Subject ▶ Change on Field

For Models ▶ 9020L, 9027, 9027L, 9027S, 9029, 9029S (Disc grinders)

Description ▶ As in the following figures 1, 2 & 3

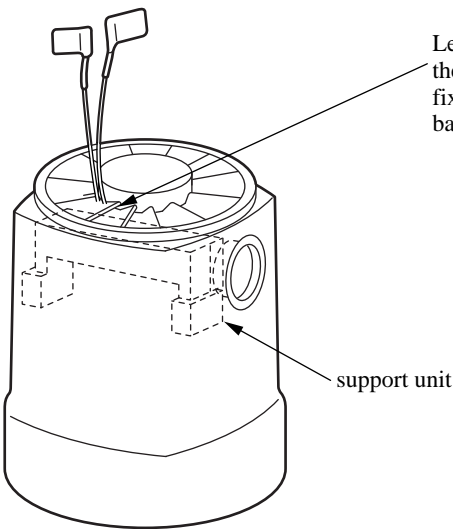
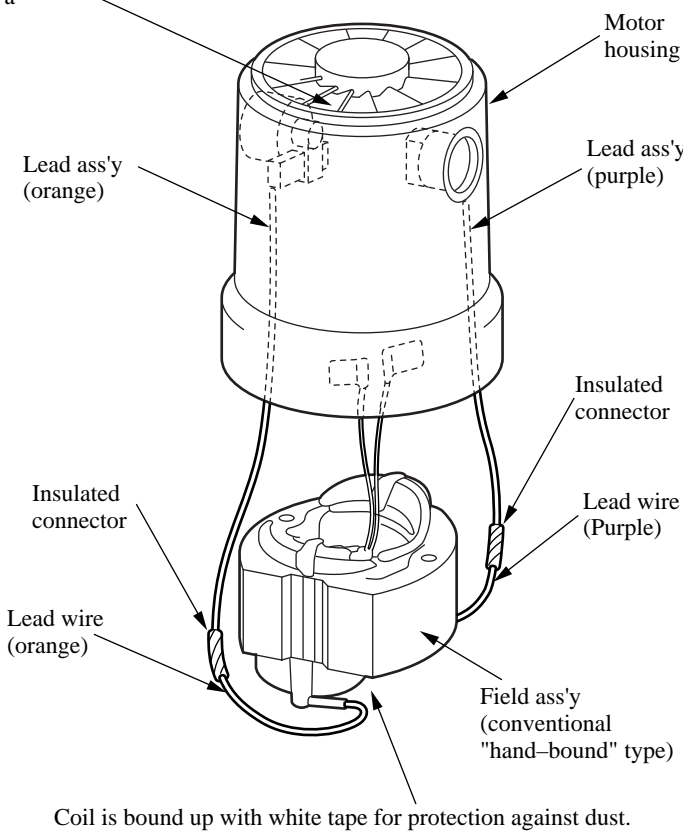
▶ Current	▶ New
Motor housing ass'y (inc. support unit) Pt no. 125036-9, price _____	Motor housing ass'y (inc. field ass'y, etc.) Pt no. & price: See List 1 Description of components: See List 2
<p>(Fig. 1)</p>  <p>Lead wire of the field is fixed with a band.</p> <p>support unit</p>	<p>(Fig. 3)</p>  <p>Motor housing</p> <p>Lead ass'y (orange)</p> <p>Lead ass'y (purple)</p> <p>Insulated connector</p> <p>Lead wire (purple)</p> <p>Field ass'y (conventional "hand-bound" type)</p> <p>Lead wire (orange)</p> <p>Coil is bound up with white tape for protection against dust.</p>
Field (auto-bound type) Pt no. & price: See List 1	
<p>(Fig. 2)</p>  <p>Coil is NOT bound up with tape.</p>

- The current motor housing in Fig.1 (Pt no. 125036-9) remains available for replacement.
- For replacement of the current field in Fig. 2, which has been discontinued, use the new motor housing ass'y in Fig. 3.

- Each component of the new motor housing ass'y is available for replacement. As to the description of its components, see the following list.
